**Western Nuclear, Inc.
Sherwood Project
Wellpinit, Washington**

**SHERWOOD TAILING
RECLAMATION PLAN**

RESPONSES TO NRC COMMENTS

Subject: Responses to NRC Staff Comments (Dated May 19, 2000) on the Termination Finding of the Western Nuclear, Inc.'s Sherwood Uranium Mill License Submitted by the Washington State Department of Health

FIGURE 3
STATIC
FAILURE SURFACE

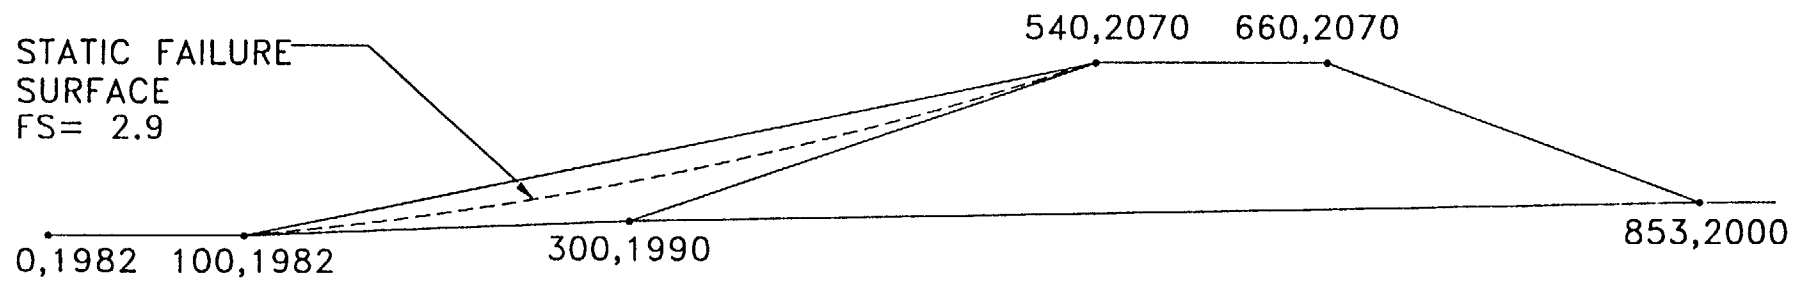
NRC Q2: *Please provide additional information and documentation to confirm that the embankment stability under saturated conditions was considered.*

The stability of the reclaimed embankment was evaluated in Appendix N of the 1994 Reclamation Plan (WNI, 1994). This evaluation is attached as Appendix C of this submittal. As can be seen, the evaluation clearly shows that the reclaimed embankment will be stable. The evaluation assumed that there would be no phreatic surface in the embankment since the embankment is separated from the tailings by an impermeable liner, the embankment is constructed of a free draining material that would drain faster than water could seep from the tailings if the liner were to fail, and that the depth to water (or a low permeable layer) is over 150 feet that would require saturation before a phreatic surface could form.
